**RE: Treatment Works Approval 16-0162  
The Chemours Company FC, LLC  
Pompton Lake Study Area Corrective Measures  
Pompton Lakes Borough, Passaic County**

This letter is to request confirmation that a permit modification is not required for the Treatment Works Approval (TWA) No. 16-0162 at The Chemours Company FC, LLC (Chemours) Pompton Lake Study Area Uplands Water Treatment Plant.

# Attachment 2 – Proposed Modified Uplands Water Treatment Plant Process Flow Diagram

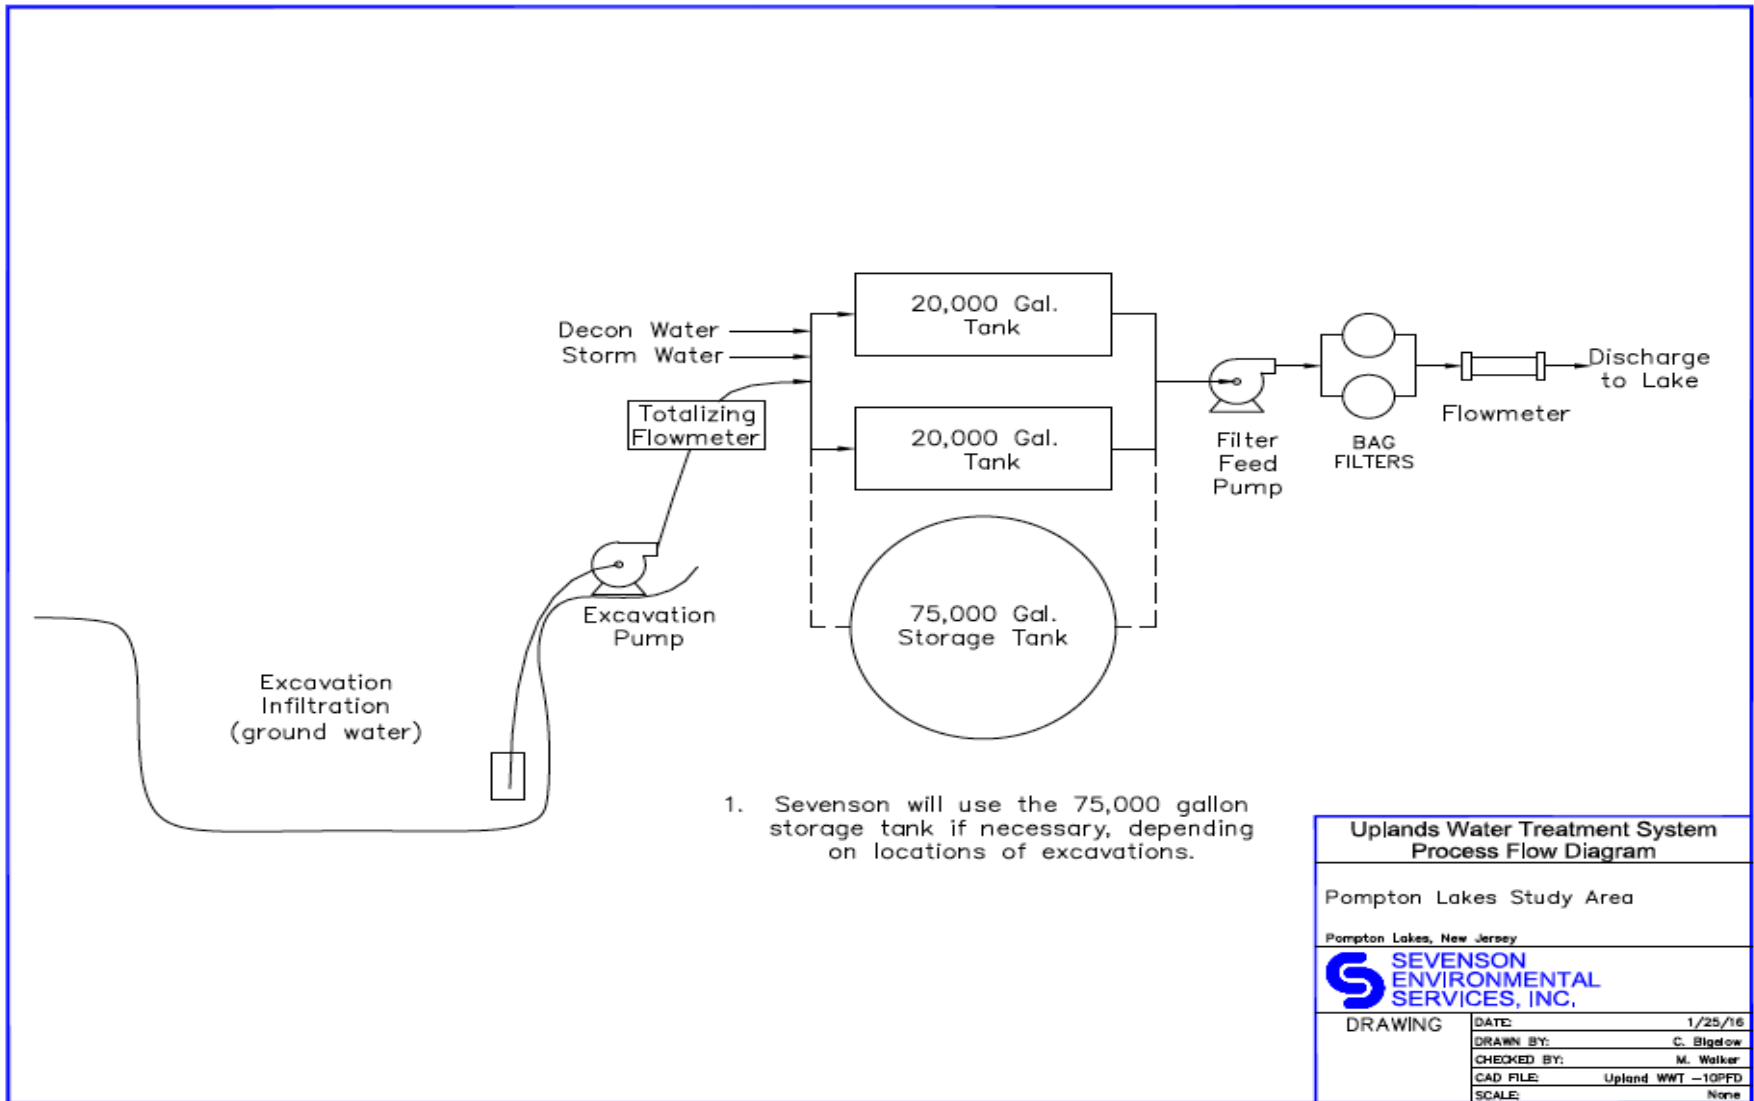
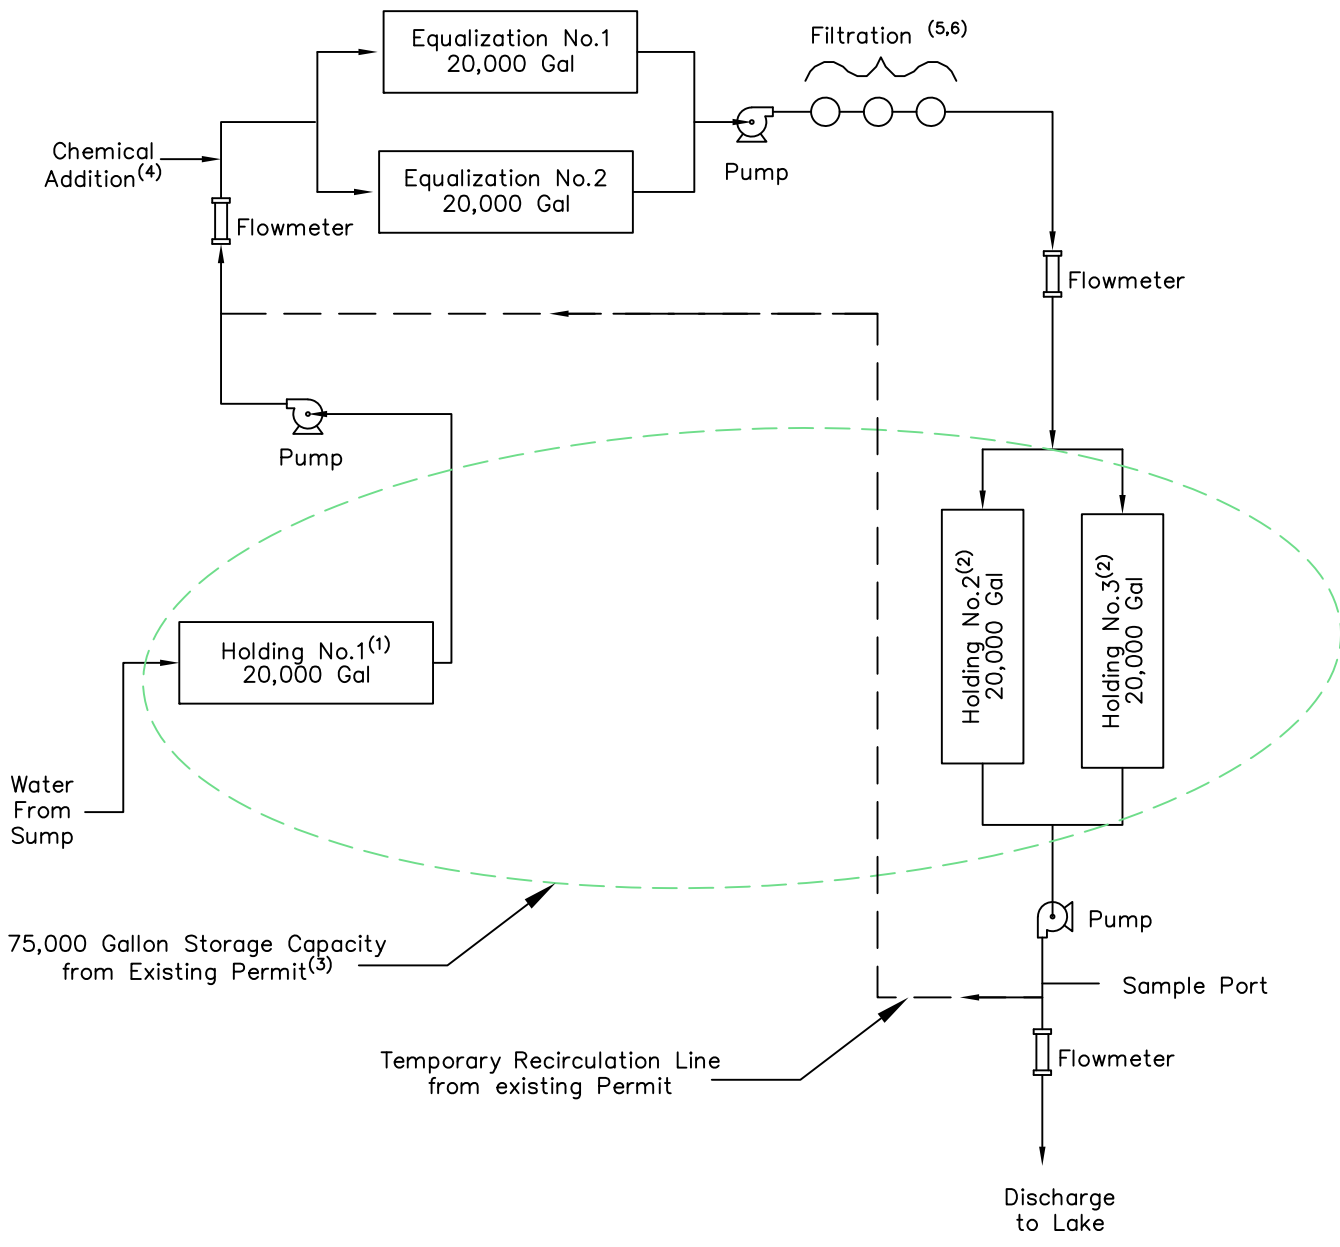
The original, approved Upland water treatment plant (see Attachment 1 for the process flow diagram) uses filtration to remove solids prior to discharge. The modifications proposed for the remediation project discharge include increased filtration and chemical addition that will be necessary for the remediation project discharge to meet regulatory limits established by the applicable permit(s). The modified Upland water treatment process flow diagram is included in Attachment 2.

Chemical addition will be initiated inline prior to the 20,000 gallon tanks contained in the approved TWA permit. The tank will be isolated when full and solids present will be allowed to settle and removed. Note that this mode of operation of the tanks with solids removal was previously described in the Uplands portion of the Operation and Maintenance Manual submitted with the original TWA application.

Water from the tank will be pumped through the filtration step consisting of the two approved bag filters (operating in series as compared to parallel in original drawing) flowing from 1-micron bags through 0.5-micron bags. Severson will add a 0.35-micron cartridge filter downstream of the two bag filters, for even finer filtration of solids prior to discharge. Conversion of the filters within parallel and addition of a cartridge filter is minor in nature and does not significantly change the layout or operation of the treatment system. The addition of a cartridge filter to the filtration step does not change the calculation on the Form DWR-175 already submitted with the original TWA application.

As shown on Attachment 2, two effluent holding tanks are being used to accumulate water from the remediation project. These tanks will allow for the evaluation of the discharge against permitted effluent limits prior to discharge. The effluent holding tanks are not part of the overall treatment process. This storage was included in the approved permit (see optional 75,000 gallon storage tank on Attachment 1) and will be operated using three 20,000 gallon storage tanks (1 influent storage tank and 2 effluent holding tanks).

- Notes:
1. Holding Tank No. 1 will be used to accumulate water (both process and rain)
  2. Holding Tanks No.2 and No.3 will be used to accumulate treated water for sampling prior to discharge and are not part of the overall treatment process
  3. The overall storage (holding capacity) has not changed as the 75,000 gallon tank in approved permit has been replaced with three 20,000 gallon tanks.
  4. Chemical addition is addressed per regulation in BGR Permit
  5. Filtration includes bags approved in existing permit with additional cartridge filter
  6. Scoring on Form DWR-175 does not change for process shown above
